RE: 4117 Cadle Creek Rd, Edgewater, MD 21037

LETTER OF EXPLANATION

Request for Variances for Single Family Dwelling

CONFIRMATION OF PRE-FILE

Proposed Site Plan

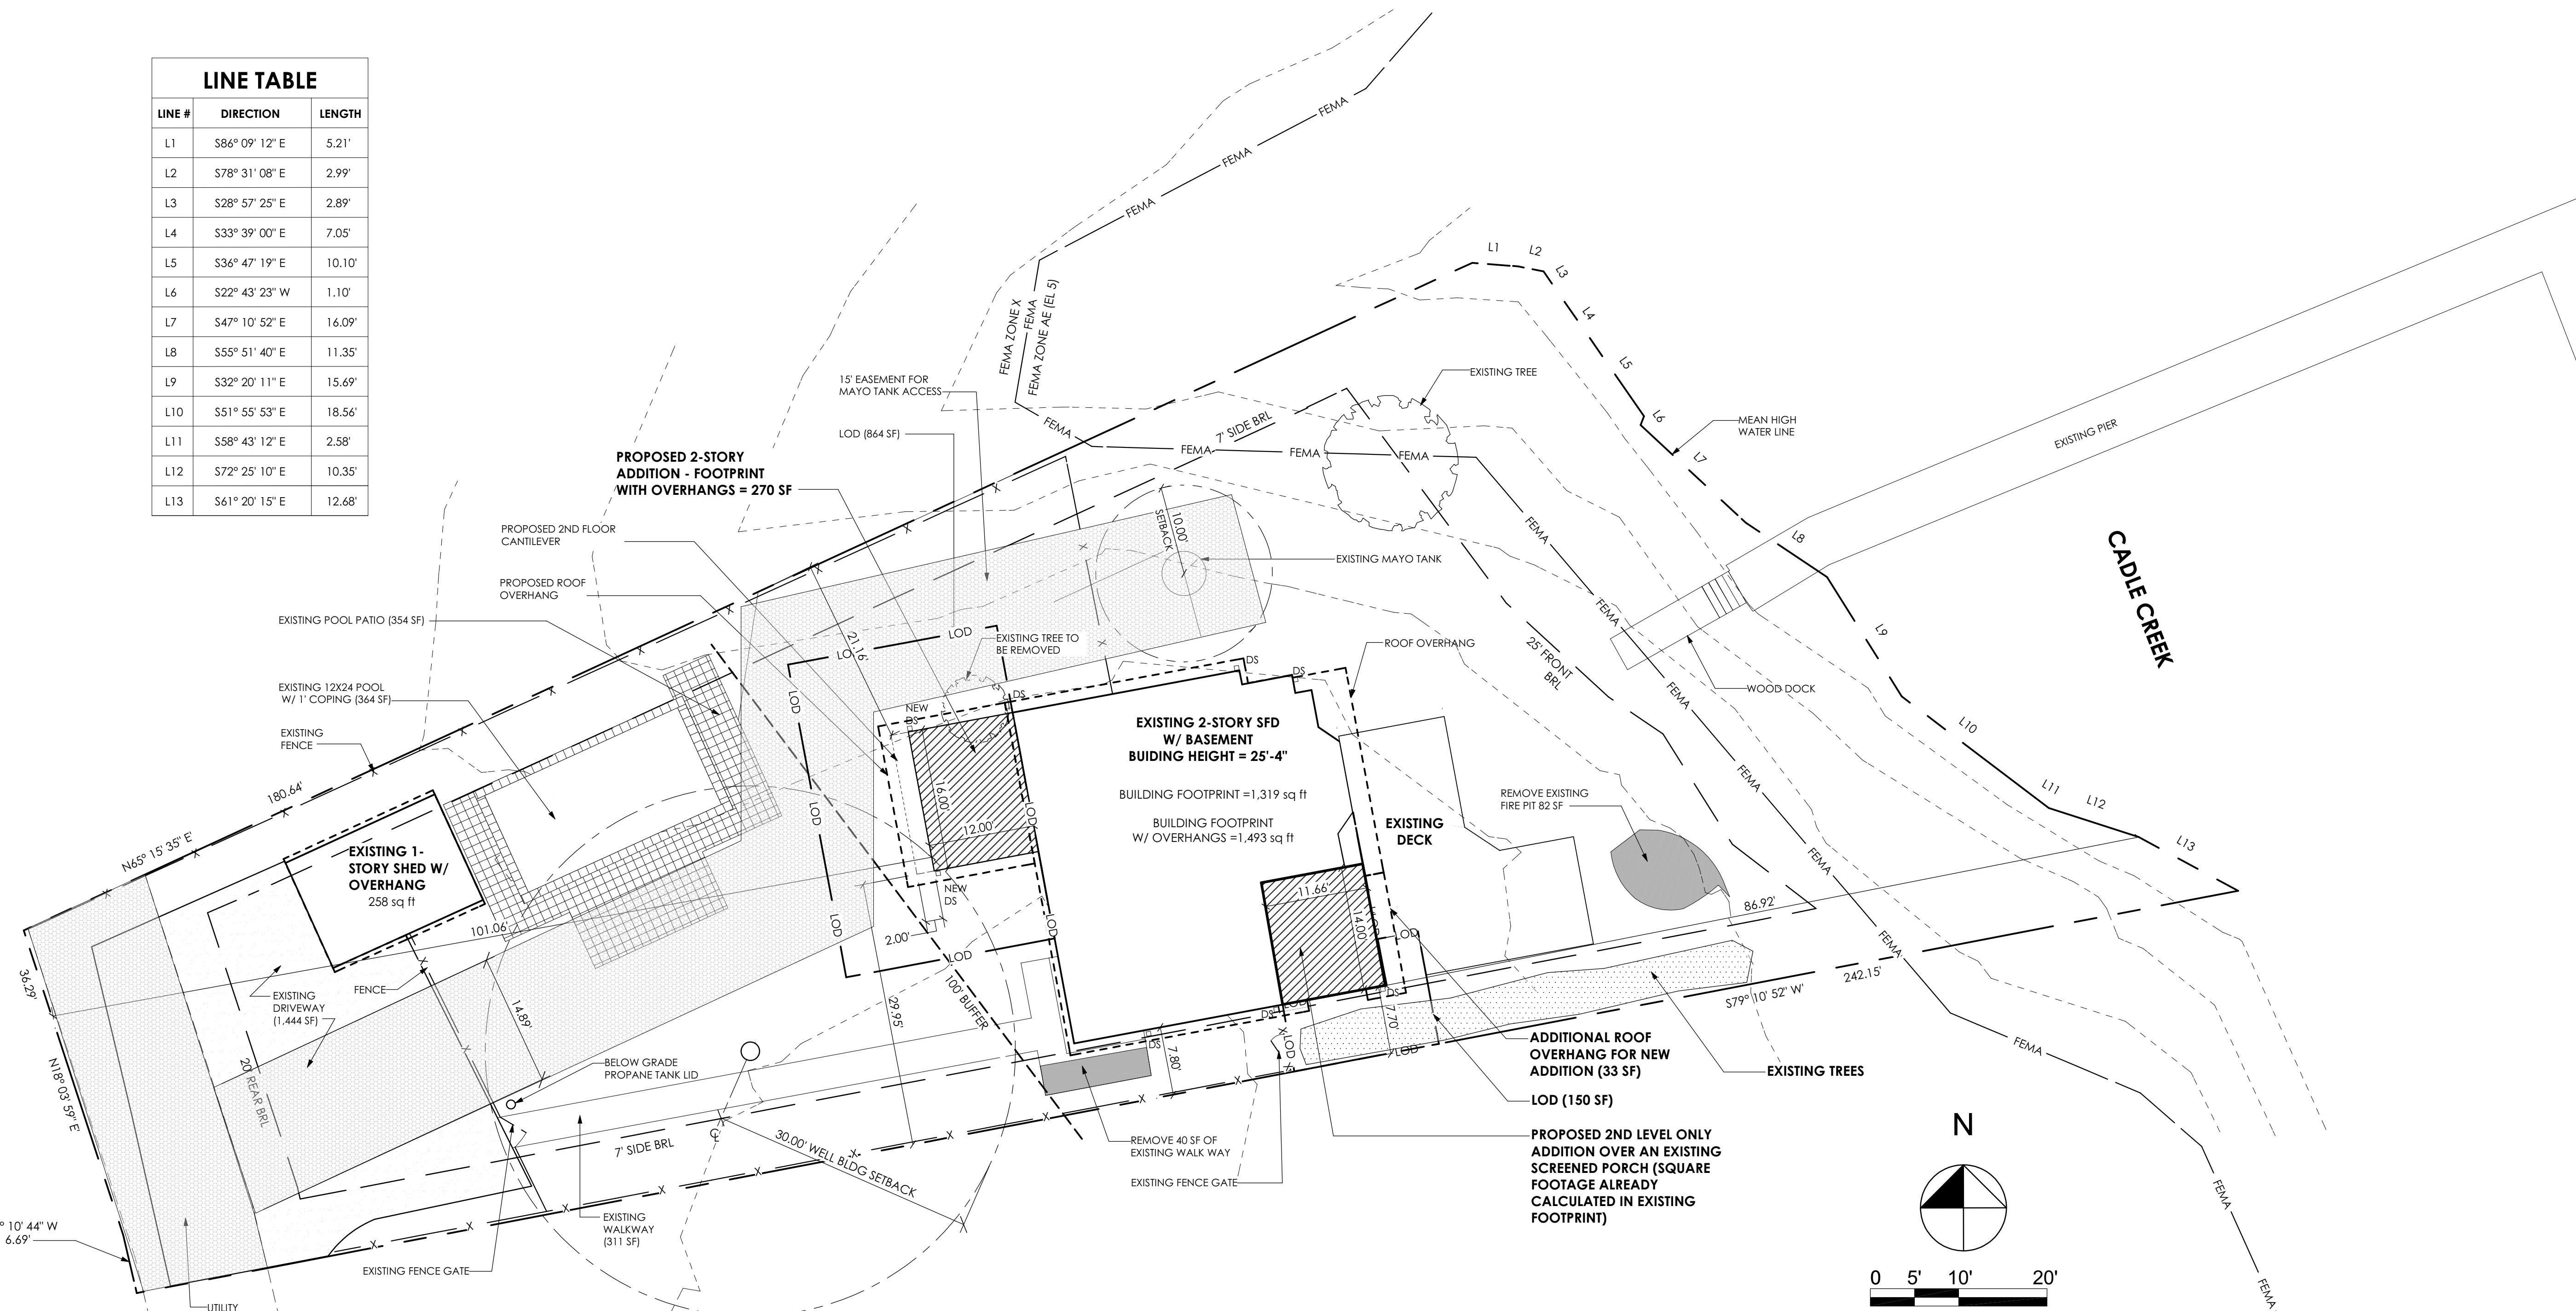
The property is located in a Buffer Modified Area (BMA) and is therefore subject to 17-8-702 not 18-13-104. Development in the BMA is permitted provided there is no new lot coverage nearer to the shoreline than the closest facade of the existing dwelling. Provided the waterside addition complies with this requirement, a variance will not be necessary for this proposal.

The 2nd story addition over the screened porch is a new use and thus new lot coverage. A variance is required if the new lot coverage is nearer to the shoreline than the closest facade of the existing principal structure.

PROPOSED SITE PLAN

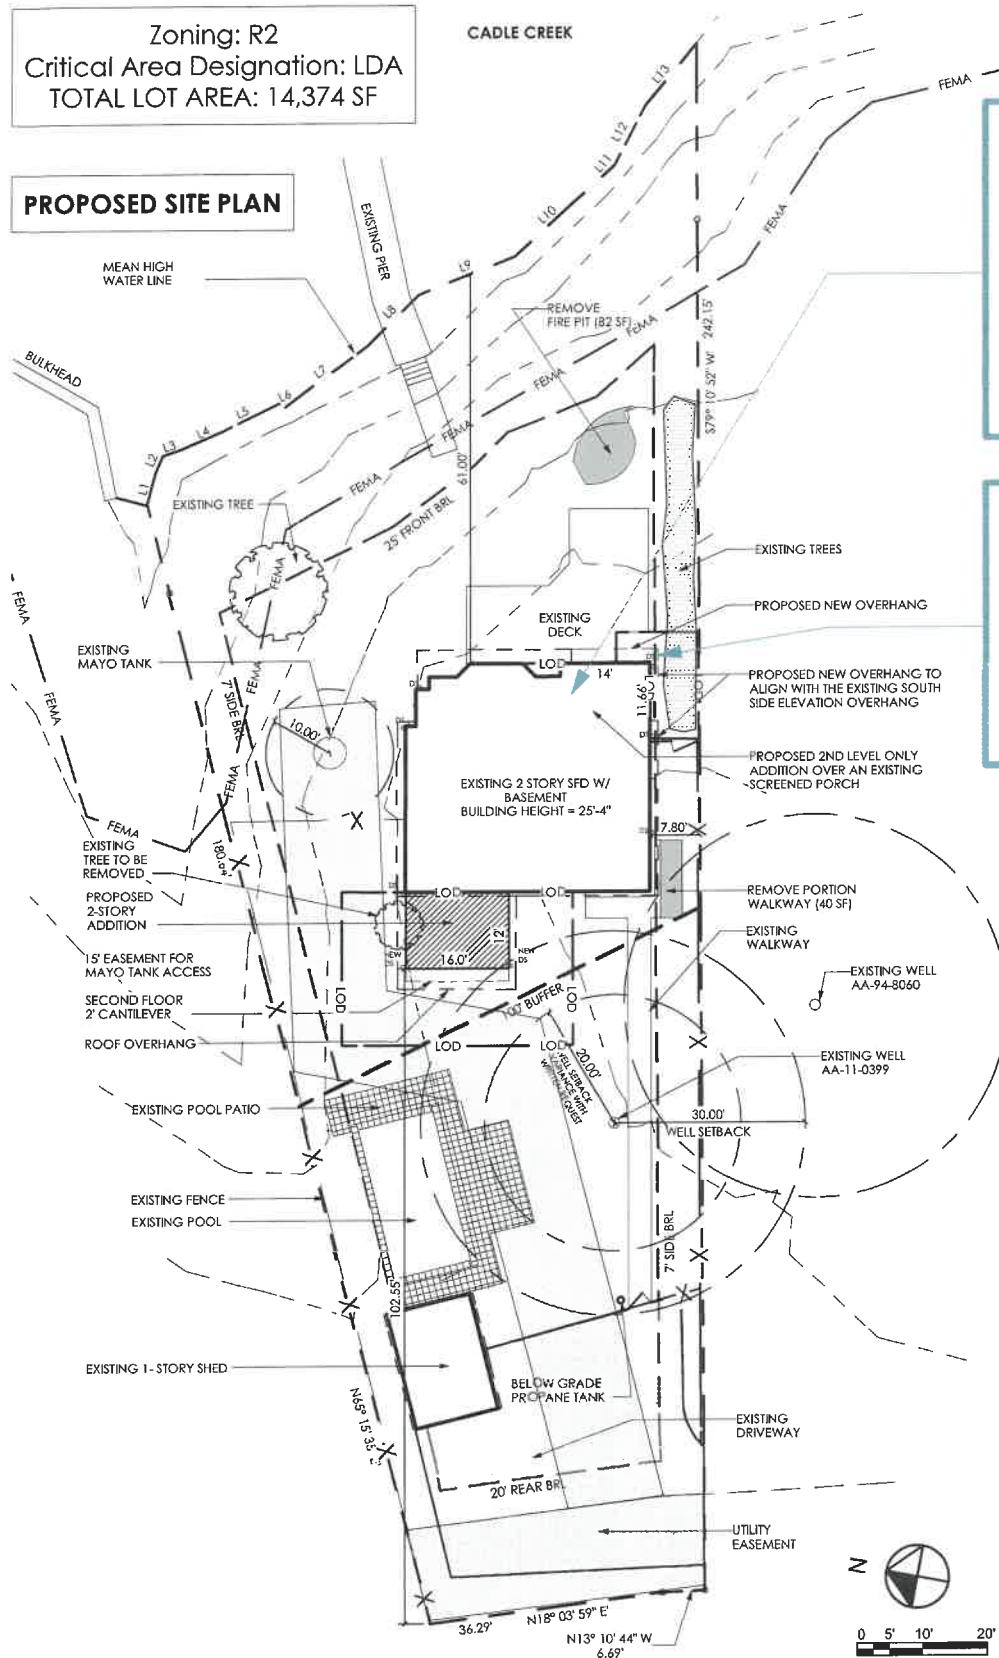
REQUEST TO BUILD A 2ND STORY ADDITION OVER THE EXISTING SCREENED PORCH ON THE WATERFRONT. THE ENTIRE EXISTING STRUCTURE, AS WELL AS THE PROPOSED ADDITION ARE LOCATED WITHIN THE BUFFER MODIFIED AREA (BMA), RELIEF FROM **17-8-702** IS REQUESTED FOR THIS ADDITION.

REQUEST TO EXTEND A NEW OVERHANG INTO THE BUILDING RESTRICTION LINE. THE NEW OVERHANG WILL ALIGN WITH THE EXISTING OVERHANG ON THE SOUTH ELEVATION. RELIEF FROM **18-4-601 BULK REGULATIONS** IS REQUESTED.
